# MEMORANDUM

FROM J.M. McONAGHY, DPE DESIGN ENGR'S SUBJECT NCI 9092 - DOME PITTING

# TECHNICAL EVALUATION-INDIVIDUAL CONCERN

PROBLEM STATEMENT	Requisition No. <u>N/A</u>	Vendor/Location <u>Newport News</u>	Documents Violated <u>CNS 1144.09-1</u>	DUKE POWER COMPANY STATION/PROJECT <u>CATAWBA</u> UNIT <u>1, X2, 3</u> NONCONFORMING ITEM REPORT USE BLACK BALL POINT PEN ONLY		
	MPS P.O. No. <u>N/A</u>	Mech/Elec System <u>N/A</u>				
	QA Required <input checked="" type="checkbox"/> Yes <input type="checkbox"/> No Condition <u>1</u>	Class <input type="checkbox"/> Q-1B'S <input type="checkbox"/> NCITape <input checked="" type="checkbox"/> Other <input type="checkbox"/> Not Practical				
	Location of Item <u>R.B. 2 (DOME)</u>			Serial No. <u>9092</u>		
EVALUATION	Description of Item and Statement of Problem <u>See Sheet 1 for description of problem</u>					
Evaluation/Disposition Responsibility <input type="checkbox"/> Const <input type="checkbox"/> Design <input type="checkbox"/> QA <input type="checkbox"/> Steam <input type="checkbox"/> Group

FIGURE 9092.1  
DOME PLATE SURFACE  
FLAW ACCEPTANCE  
CRITERIA

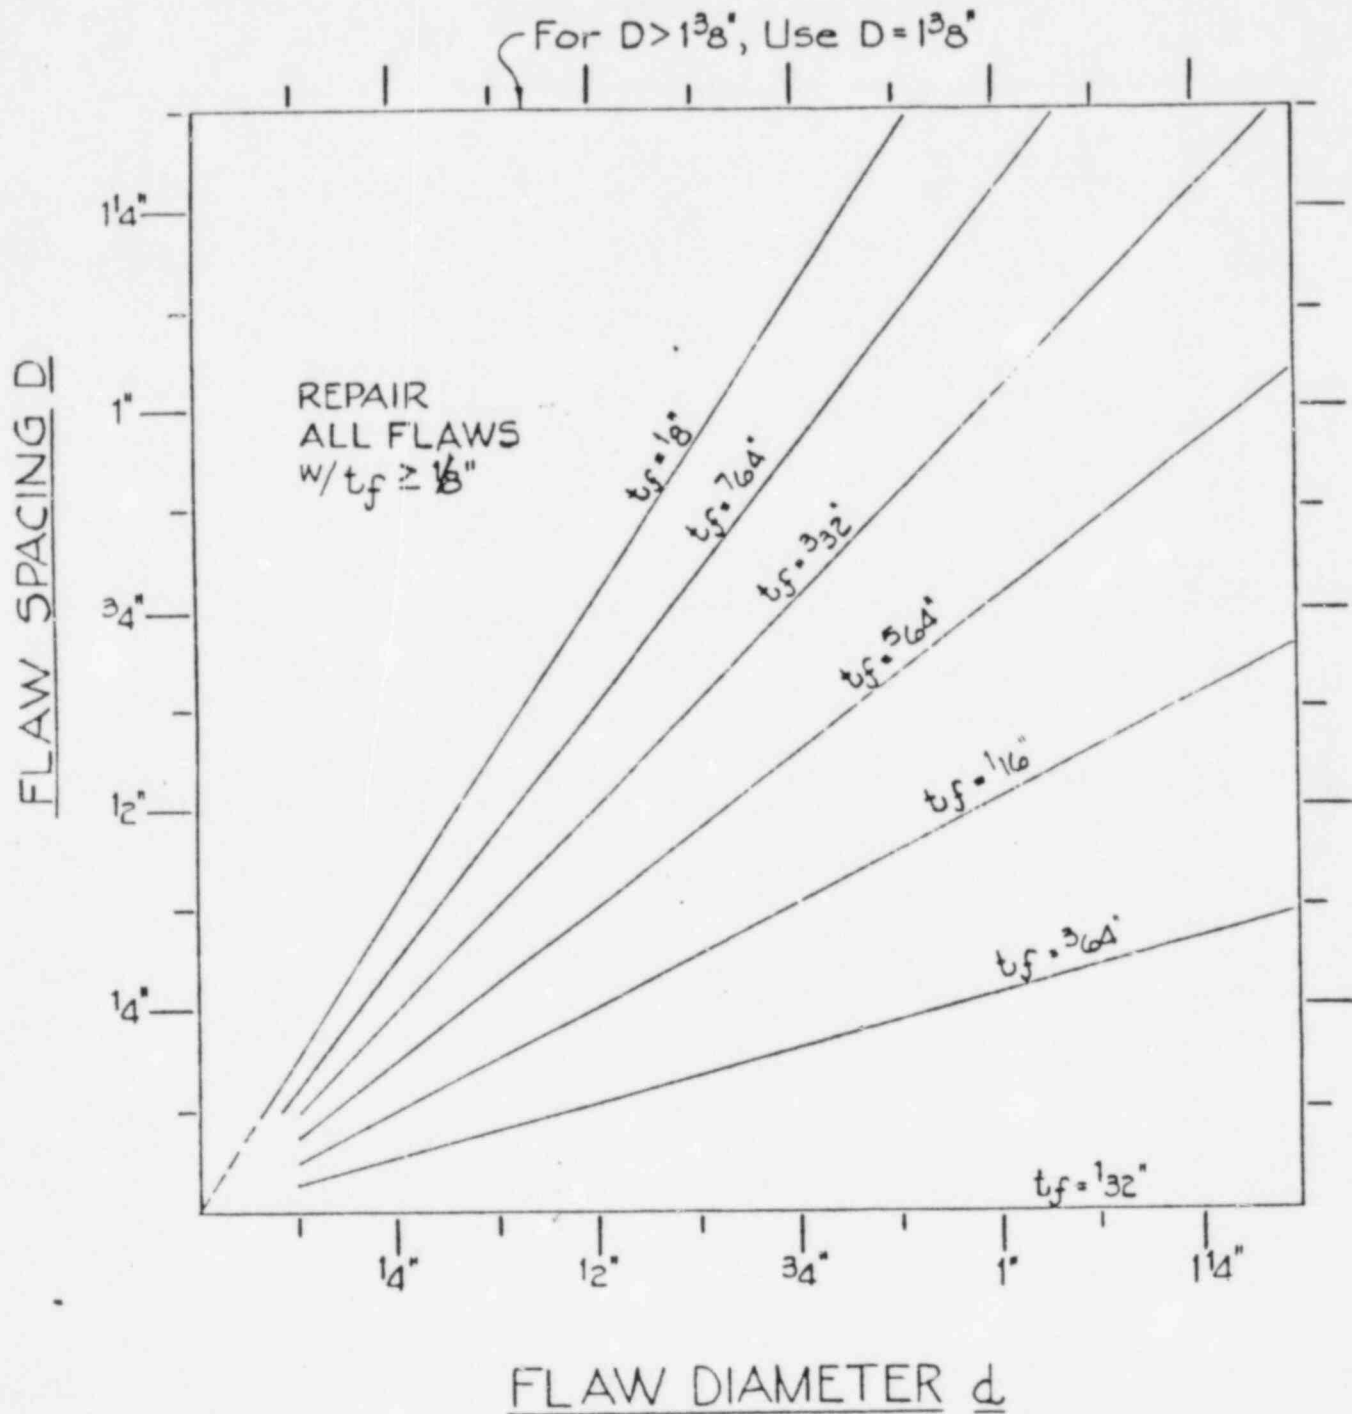
3. The remaining flaws shall be inspected to determine their acceptability using the attached Figure 9092.1. The acceptability of a given flaw will be determined by the size of the surface which it covers, the depth of the flaw, and the proximity of the flaw to other flaws. Surface defects failing this criteria shall be weld repaired according to ASME procedures.

4. The following definitions apply to the variables used in Figure 9092.1:
  - a.  $\underline{d}$  (flaw diameter): The dimension of the surface flaw in the direction of the next adjacent flaw. For circular pits surrounded by a circular pattern of smaller pits,  $\underline{d}$  shall be taken as the distance across the circular pattern.

- c.  $\underline{t}_f$  (flaw depth): The maximum penetration of the flaw measured from the unflawed surface.
5. In applying Figure 9092.1, the two surface measurements  $\underline{D}$  and  $\underline{d}$  should be made first. With these two measurements, one point on the figure is determined. This point will lie between two flaw depth lines. The flaw depth indicated by the line immediately below the point given by  $\underline{D}$  and  $\underline{d}$  is acceptable, while the flaw depth given by the line immediately above the point is unacceptable. For points lying on a given flaw depth line, the flaw depth given by that line is acceptable. For example, a flaw with  $\underline{D}=1/2$ " and  $\underline{d}=5/8$ " is acceptable for a flaw depth of  $5/64$ " and is unacceptable for a flaw depth of  $3/32$ ". The actual flaw depth should be compared to the acceptable value to determine whether repair is required. Repairs may be made either to the flaw in question or to an adjacent flaw to arrive at a combination meeting this criteria.

6. Figure 9092.1 assumes an identical flaw on the opposite face of the dome plate. If it can be verified that in the area of a given flaw no surface flaws are present on the opposite face, the allowable depth given by Figure 9092.1 may be multiplied by two.

FIGURE 9092.1  
DOME PLATE SURFACE  
FLAW ACCEPTANCE  
CRITERIA

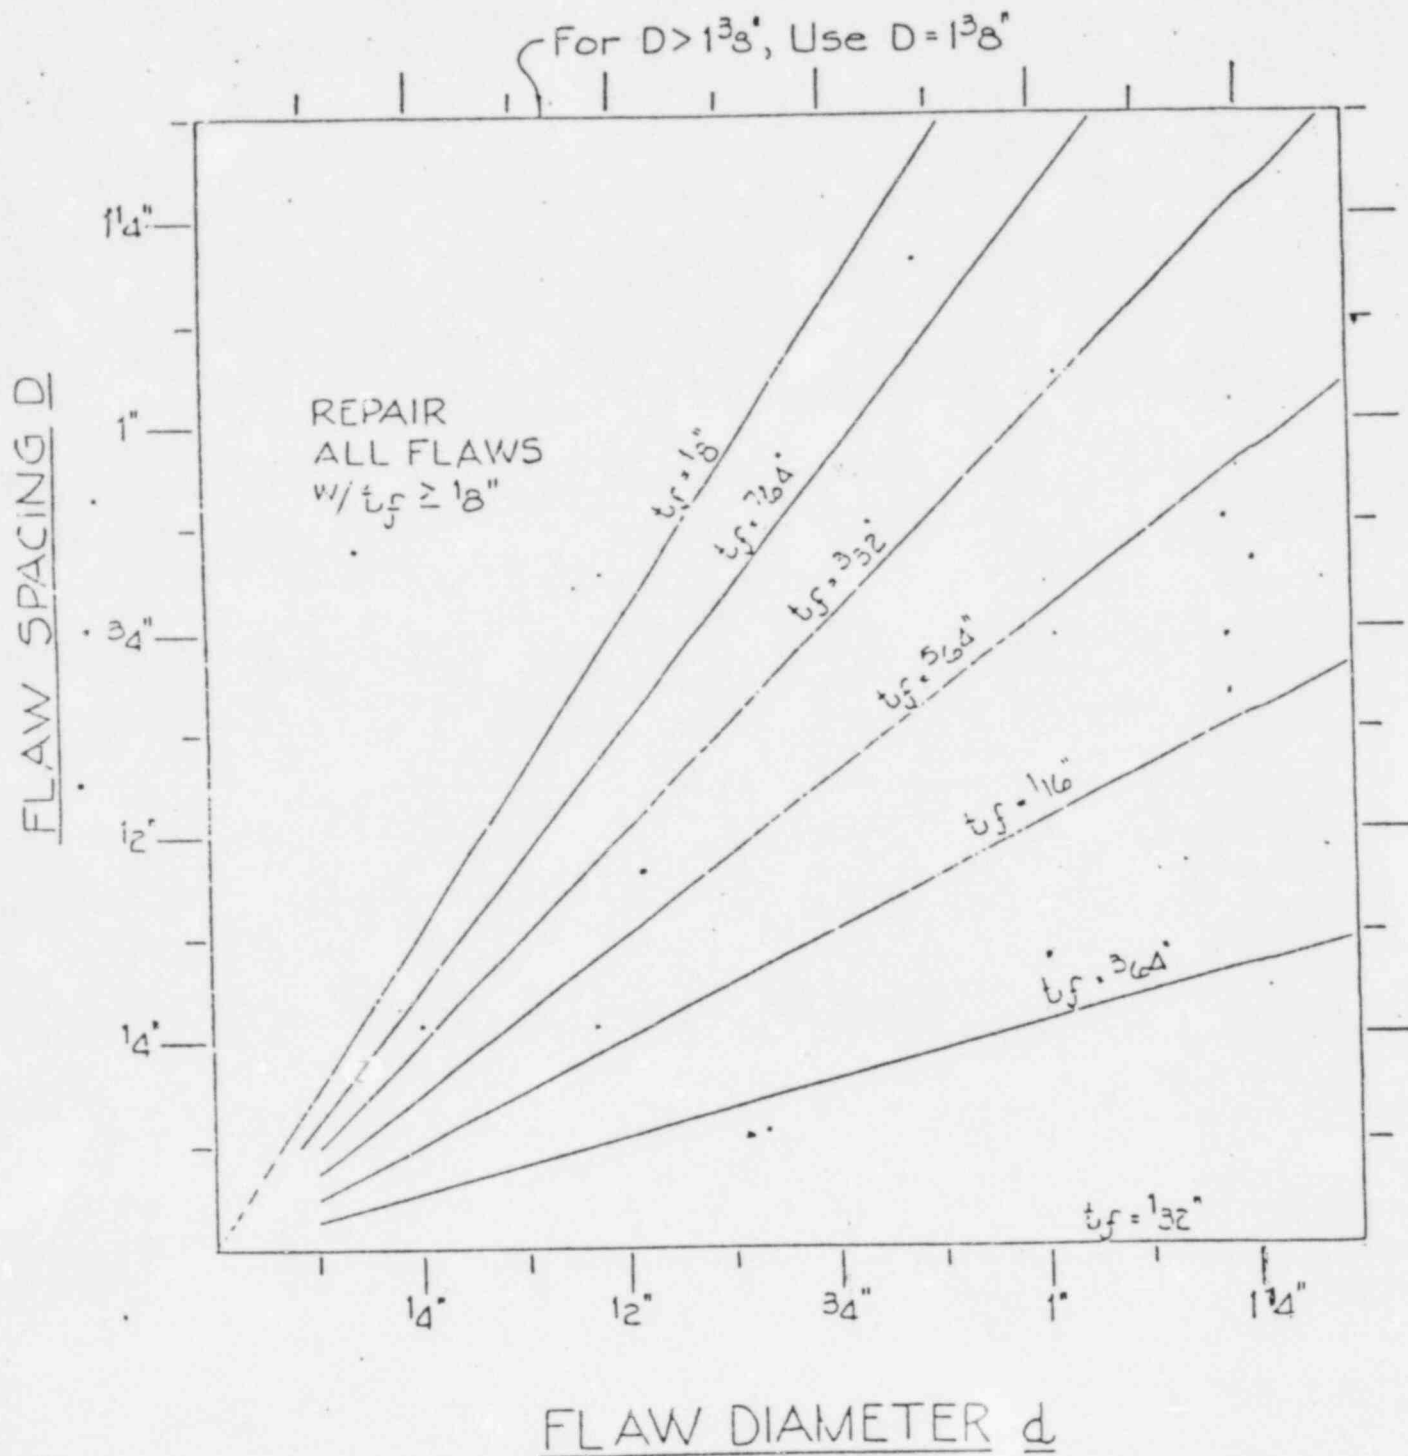
3. The remaining flaws shall be inspected to determine their acceptability using the attached Figure 9092.1. The acceptability of a given flaw will be determined by the size of the surface which it covers, the depth of the flaw, and the proximity of the flaw to other flaws. Surface defects failing this criteria shall be weld repaired according to ASME procedures.

4. The following definitions apply to the variables used in Figure 9092.1:
  - a.  $\underline{d}$  (flaw diameter): The dimension of the surface flaw in the direction of the next adjacent flaw. For circular pits surrounded by a circular pattern of smaller pits,  $\underline{d}$  shall be taken as the distance across the circular pattern.

- c.  $\underline{t}_f$  (flaw depth): The maximum penetration of the flaw measured from the unflawed surface.
5. In applying Figure 9092.1, the two surface measurements  $\underline{D}$  and  $\underline{d}$  should be made first. With these two measurements, one point on the figure is determined. This point will lie between two flaw depth lines. The flaw depth indicated by the line immediately below the point given by  $\underline{D}$  and  $\underline{d}$  is acceptable, while the flaw depth given by the line immediately above the point is unacceptable. For points lying on a given flaw depth line, the flaw depth given by that line is acceptable. For example; a flaw with  $\underline{D}=1/2"$  and  $\underline{d}=5/8"$  is acceptable for a flaw depth of  $5/64"$  and is unacceptable for a flaw depth of  $3/32"$ . The actual flaw depth should be compared to the acceptable value to determine whether repair is required. Repairs may be made either to the flaw in question or to an adjacent flaw to arrive at a combination meeting this criteria.

6. Figure 9092.1 assumes an identical flaw on the opposite face of the dome plate. If it can be verified that in the area of a given flaw no surface flaws are present on the opposite face, the allowable depth given by Figure 9092.1 may be multiplied by two.

FIGURE 9092.1  
DOME PLATE SURFACE  
FLAW ACCEPTANCE  
CRITERIA

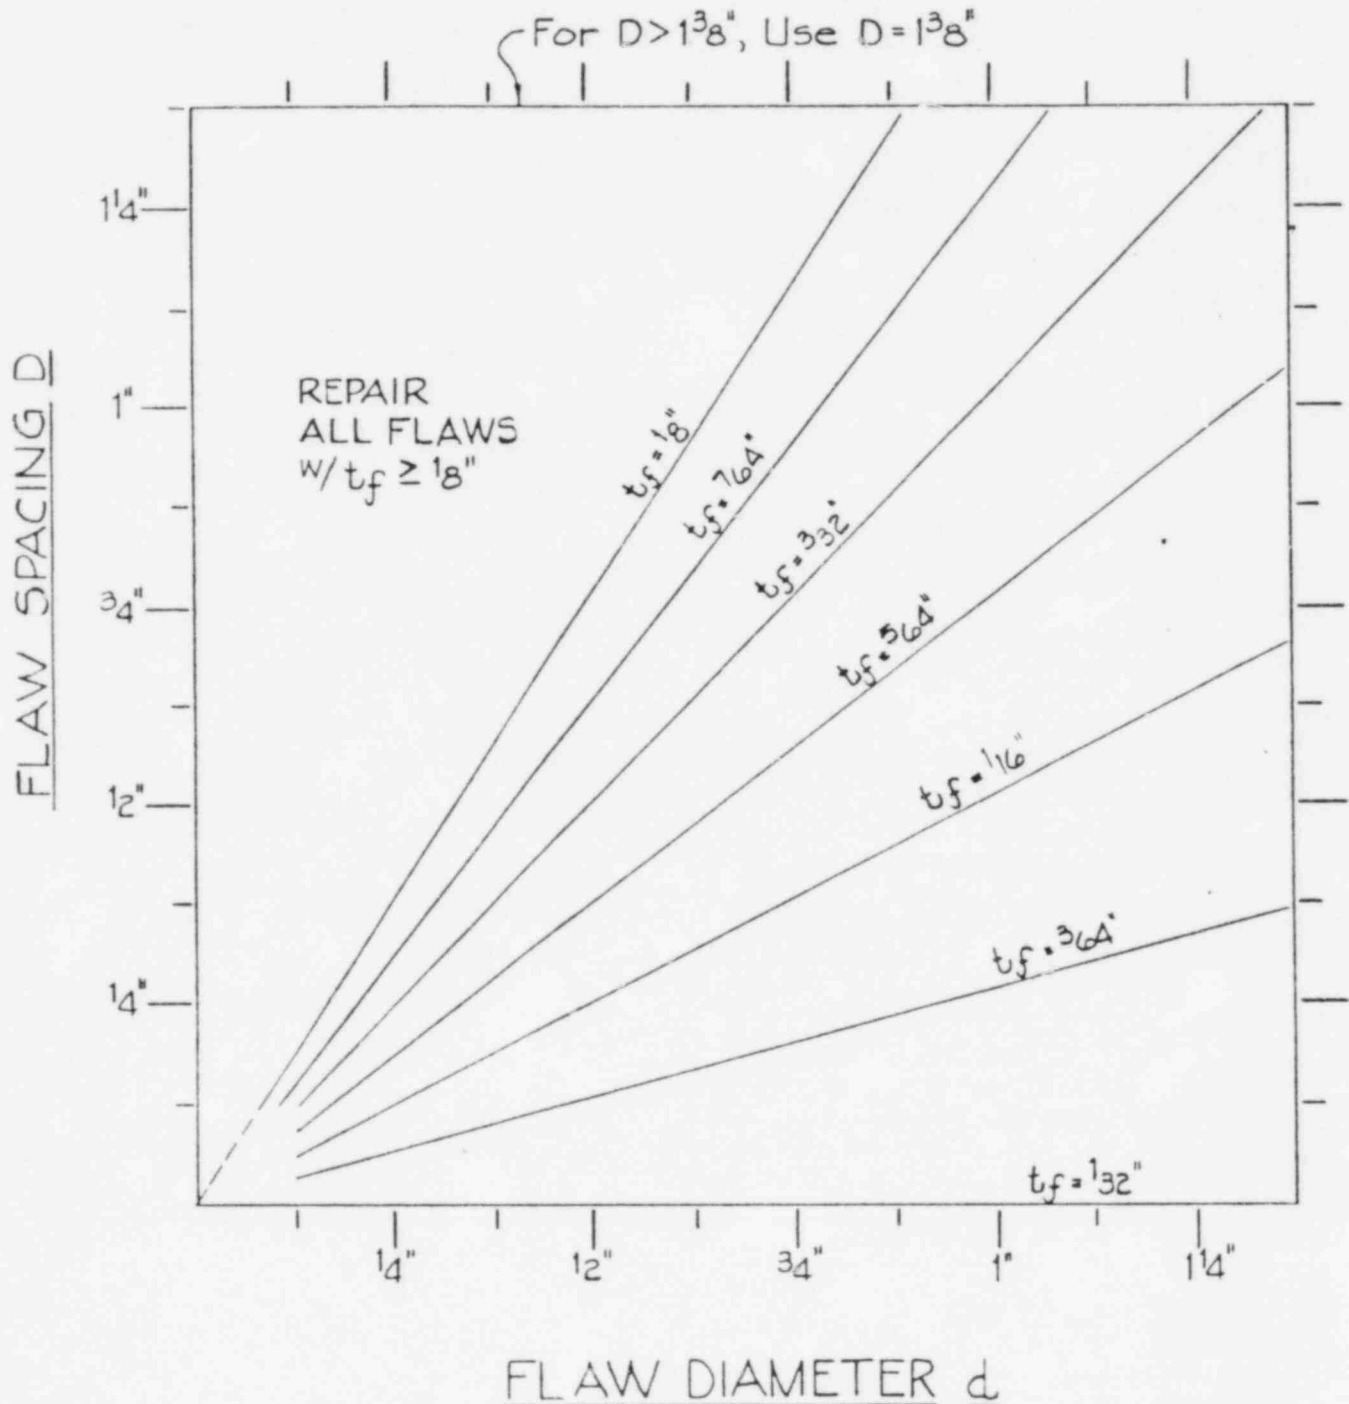
3. The remaining flaws shall be inspected to determine their acceptability using the attached Figure 9092.1. The acceptability of a given flaw will be determined by the size of the surface which it covers, the depth of the flaw, and the proximity of the flaw to other flaws. Surface defects failing this criteria shall be weld repaired according to ASME procedures.

4. The following definitions apply to the variables used in Figure 9092.1:
  - a.  $\underline{d}$  (flaw diameter): The dimension of the surface flaw in the direction of the next adjacent flaw. For circular pits surrounded by a circular pattern of smaller pits,  $\underline{d}$  shall be taken as the distance across the circular pattern.

- c.  $\underline{t}_f$  (flaw depth): The maximum penetration of the flaw measured from the unflawed surface.
5. In applying Figure 9092.1, the two surface measurements  $\underline{D}$  and  $\underline{d}$  should be made first. With these two measurements, one point on the figure is determined. This point will lie between two flaw depth lines. The flaw depth indicated by the line immediately below the point given by  $\underline{D}$  and  $\underline{d}$  is acceptable, while the flaw depth given by the line immediately above the point is unacceptable. For points lying on a given flaw depth line, the flaw depth given by that line is acceptable. For example, a flaw with  $\underline{D}=1/2"$  and  $\underline{d}=5/8"$  is acceptable for a flaw depth of  $5/64"$  and is unacceptable for a flaw depth of  $3/32"$ . The actual flaw depth should be compared to the acceptable value to determine whether repair is required. Repairs may be made either to the flaw in question or to an adjacent flaw to arrive at a combination meeting this criteria.

6. Figure 9092.1 assumes an identical flaw on the opposite face of the dome plate. If it can be verified that in the area of a given flaw no surface flaws are present on the opposite face, the allowable depth given by Figure 9092.1 may be multiplied by two.

IN DEVELOPING CONSTRUCTION PROCEDURE FOR INSPECTION OF DOME PLATE PITTING, THE FIELD HAS REQUESTED THAT THE ACCEPTANCE CRITERIA OF FIGURE 9092.1 BE RESTATED IN TABULAR FORMAT TO REDUCE THE POTENTIAL FOR ERRORS AND DISAGREEMENTS IN READING THE CHART. THIS DOES NOT CONSTITUTE A CHANGE IN THE RESOLUTION OF NCI 9092, BUT IS MERELY A RESTATEMENT OF THE CRITERIA IN A DIFFERENT FORM.

FIGURE 9092.1  
DOME PLATE SURFACE  
FLAW ACCEPTANCE  
CRITERIA

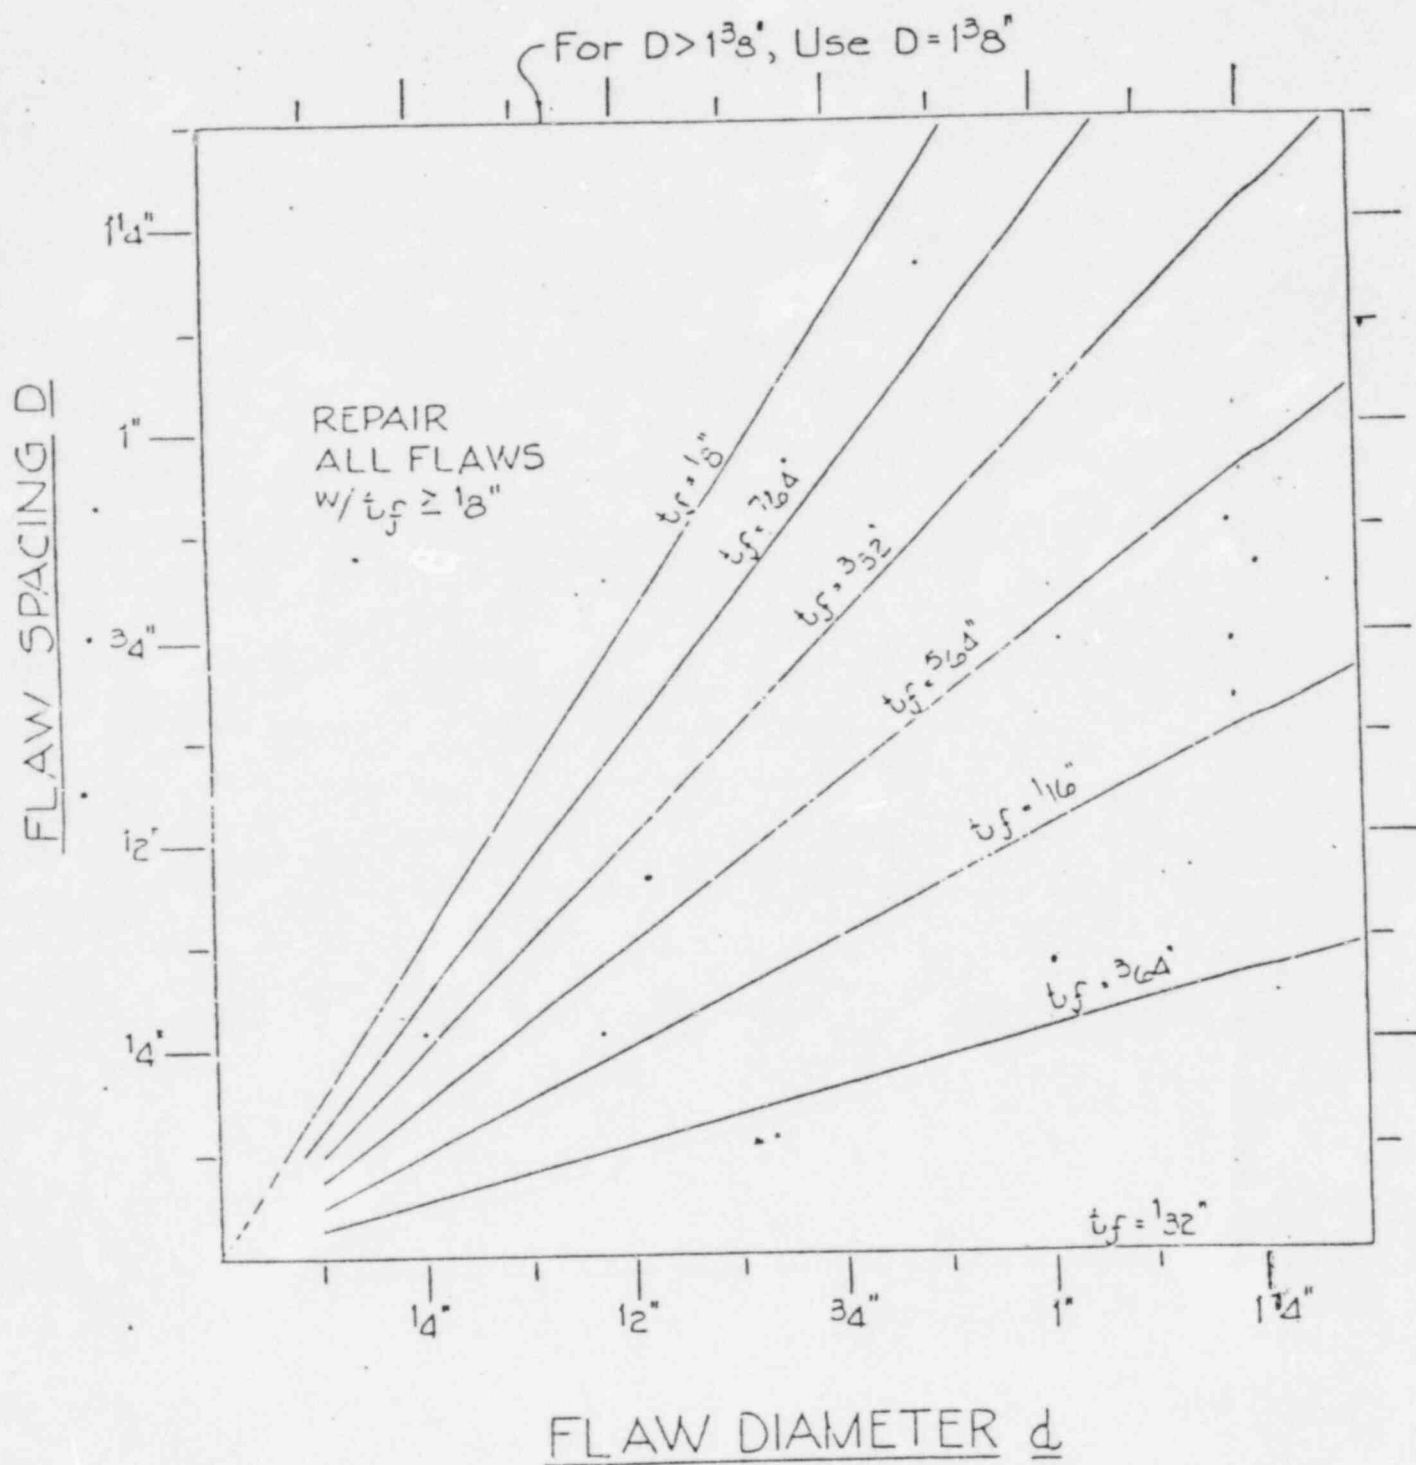
3. The remaining flaws shall be inspected to determine their acceptability using the attached Figure 9092.1. The acceptability of a given flaw will be determined by the size of the surface which it covers, the depth of the flaw, and the proximity of the flaw to other flaws. Surface defects failing this criteria shall be weld repaired according to ASME procedures.

4. The following definitions apply to the variables used in Figure 9092.1:
  - a.  $\underline{d}$  (flaw diameter): The dimension of the surface flaw in the direction of the next adjacent flaw. For circular pits surrounded by a circular pattern of smaller pits,  $\underline{d}$  shall be taken as the distance across the circular pattern.

- c.  $\underline{t}_f$  (flaw depth): The maximum penetration of the flaw measured from the unflawed surface.
5. In applying Figure 9092.1, the two surface measurements  $\underline{D}$  and  $\underline{d}$  should be made first. With these two measurements, one point on the figure is determined. This point will lie between two flaw depth lines. The flaw depth indicated by the line immediately below the point given by  $\underline{D}$  and  $\underline{d}$  is acceptable, while the flaw depth given by the line immediately above the point is unacceptable. For points lying on a given flaw depth line, the flaw depth given by that line is acceptable. For example; a flaw with  $\underline{D}=1/2"$  and  $\underline{d}=5/8"$  is acceptable for a flaw depth of  $5/64"$  and is unacceptable for a flaw depth of  $3/32"$ . The actual flaw depth should be compared to the acceptable value to determine whether repair is required. Repairs may be made either to the flaw in question or to an adjacent flaw to arrive at a combination meeting this criteria.

6. Figure 9092.1 assumes an identical flaw on the opposite face of the dome plate. If it can be verified that in the area of a given flaw no surface flaws are present on the opposite face, the allowable depth given by Figure 9092.1 may be multiplied by two.
